SUTHERLAND SHIRE COUNCIL ASSESSMENT REPORT

Panel Reference	PPSSSH-10
DA Number	MA19/0303
LGA	Sutherland Shire
Proposed Development:	S4.56 modification to DA18/0323 - changes to the apartment mix, internal layouts and external facade
Street Address:	S/P 545, S/P 9336, S/P 48254, S/P 67206 – 5 to 9 Ozone Street, Cronulla
Applicant/Owner:	Ozone Cronulla Pty Ltd
Date of DA lodgement	26 September 2019
Number of Submissions:	3
Recommendation:	Approval
Regional Development Criteria (Schedule 7 of the SEPP (State and Regional Development) 2011	
List of all relevant s4.15(1)(a) matters	<p>i.e. any:</p> <ul style="list-style-type: none"> relevant environmental planning instruments proposed instrument that is or has been the subject of public consultation under the Act and that has been notified to the consent authority relevant development control plan relevant planning agreement that has been entered into under section 7.4, or any draft planning agreement that a developer has offered to enter into under section 7.4 coastal zone management plan relevant regulations e.g. Regs 92, 93, 94, 94A, 288

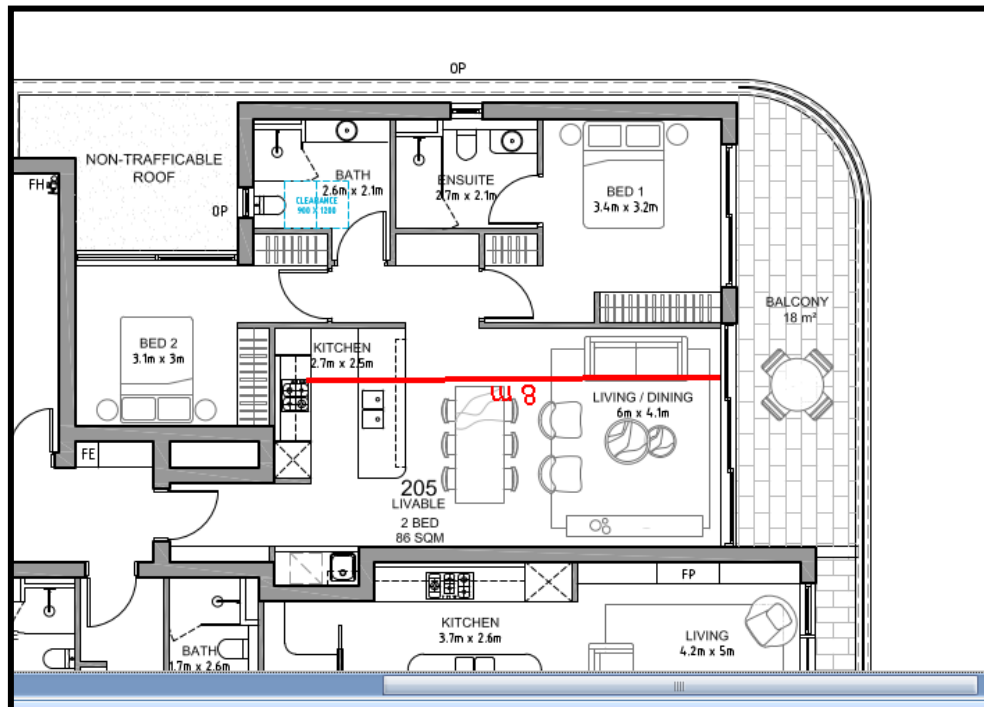
The modified design does not comply with the ADG, resulting in 22 out of 38 apartments (57%) receiving 2 hours of solar access to both their living and private open space areas. A further 3 of 38 apartments achieving compliant solar access to their private open spaces only, which equates to a total of 65% of units (a shortfall of 2 units). It is acknowledged, however, that a further 5 of the remaining apartments achieve compliant solar access to their second living areas, which equates to a total of 71% of all units.

Notwithstanding the non-compliance with solar access, the design guidelines for solar access encourages buildings to be designed *maximising a northerly aspect* and *minimise the number of single south aspect apartments*. In addition, the ADG states that *where significant views are oriented away from the desired aspect for direct sunlight* achieving compliant solar access may not be possible. In this case, the design includes 14 apartments with a northerly aspect, 15 apartments with an easterly aspect and 9 apartments with a south easterly aspect.

The building has been designed with units taking advantage of either a northerly or easterly aspect, resulting in only 9 units with a south easterly aspect. In addition, five of the south easterly aspect units have a second living area at the rear with a north facing window that will receive 2 hours of solar access.

While 5 units will not receive 2 hours of solar access to their private open space due to the site configuration, there will be two common open space areas available on the site. One located in the front north eastern corner and a second at the rear on the western side of the site. Both these spaces will receive adequate solar access providing residents with options to utilise during winter.

In this case, given the sites orientation and that most units will have either a northerly or easterly aspect, the proposal is acceptable.
